A/E Firm: WRA Architects		PM Firm: CBRE Vanir JV	Date: 12-10-2025
Org #: 159	School Name: L.L. Hotchkiss Elementary School	Bid Pack #/ CSP#: 207325	Addendum #: 1

**DALLAS INDEPENDENT SCHOOL DISTRICT
PROCUREMENT SERVICES
ADDENDUM NO. 1
CSP 207325 – L.L. Hotchkiss Elementary School - Renovation**

The Purpose of this Addendum No. 1 is to provide an alternate bid and updated the drawings and specifications:

DIMENSION CONTROL
AND PAVING PLAN -
BID ALTERNATE
C2.02

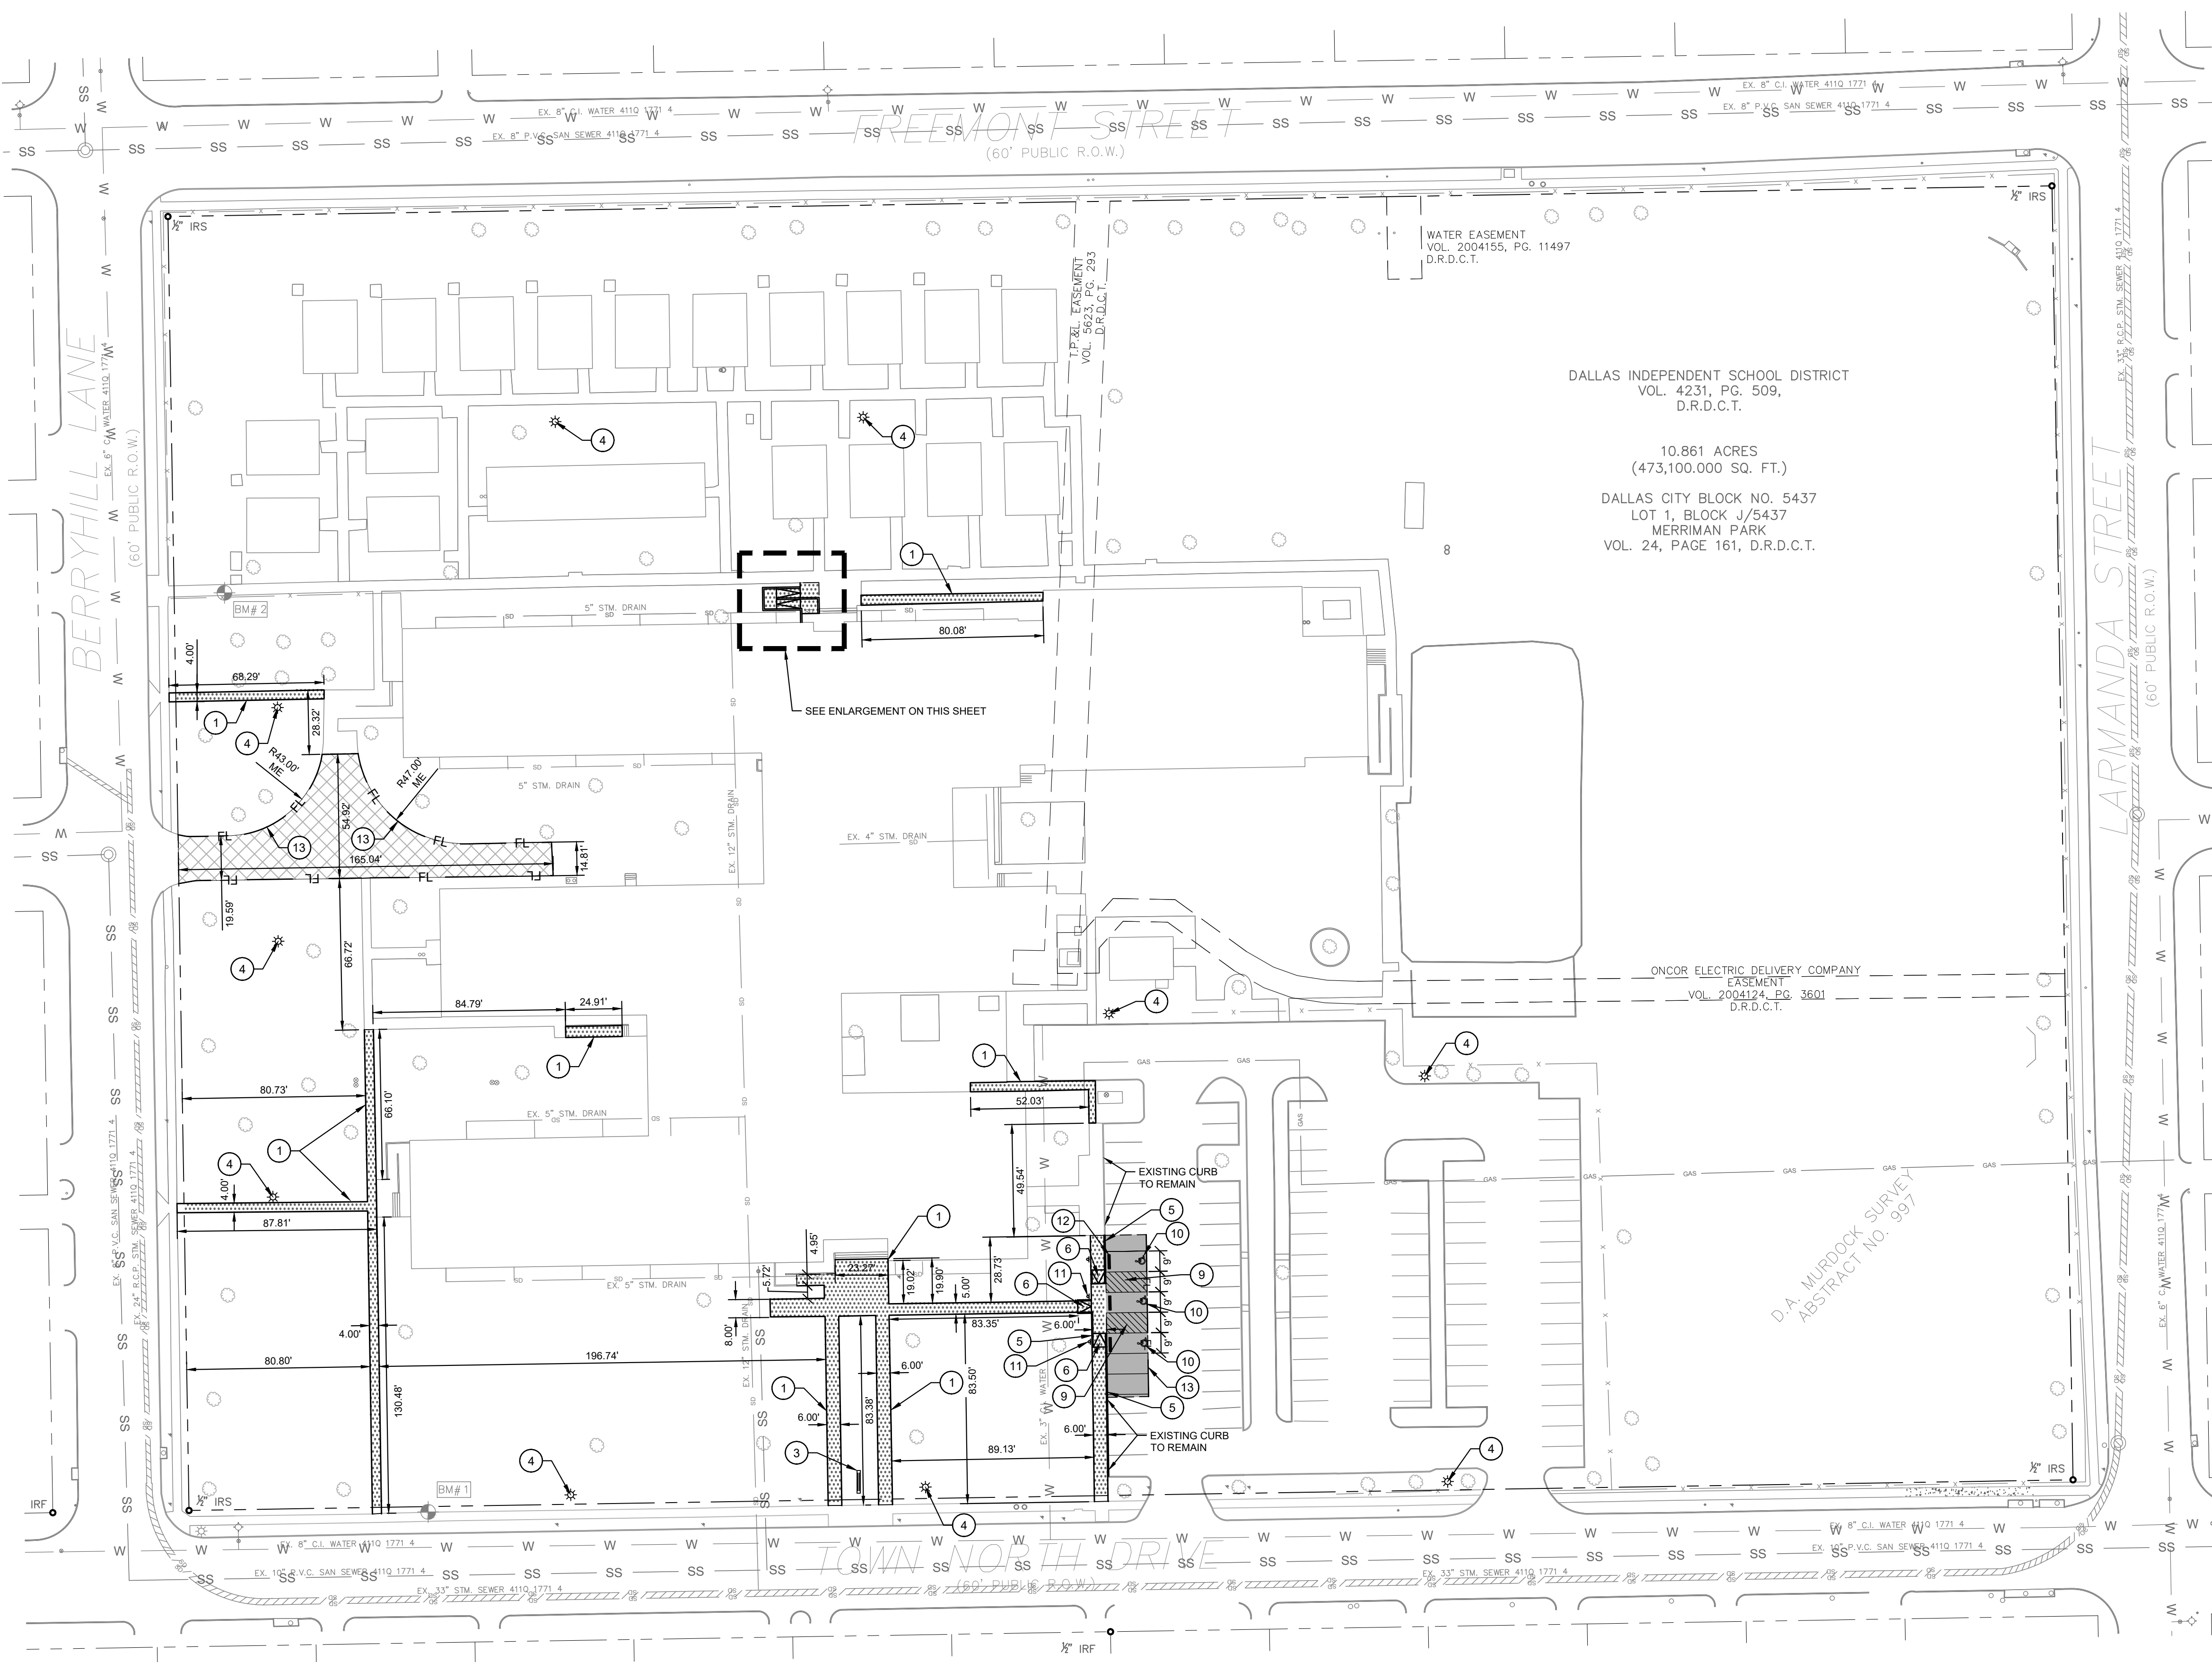
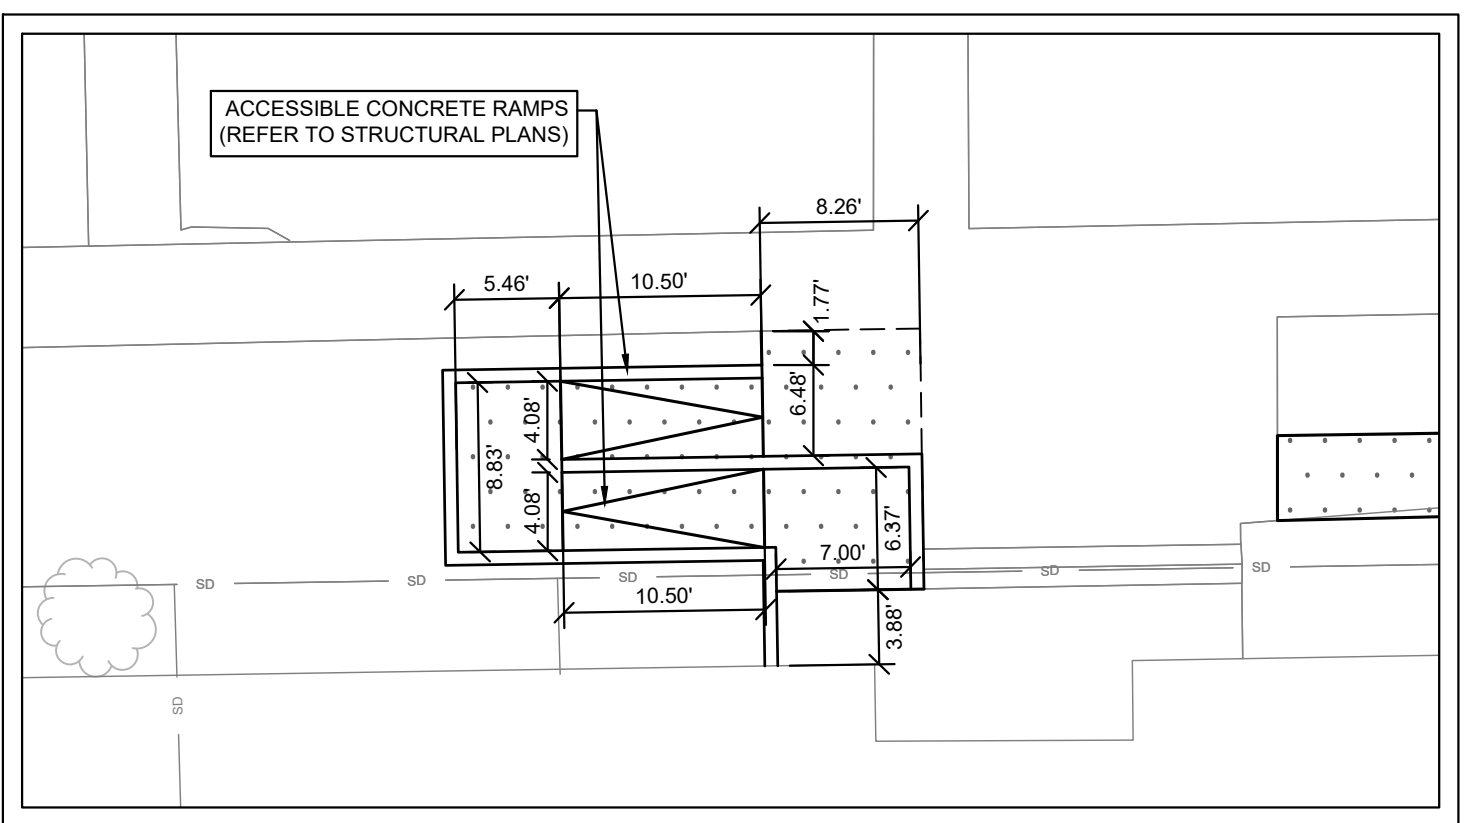
- A. REVISED** the south parking for proposed sidewalk and ADA stalls only
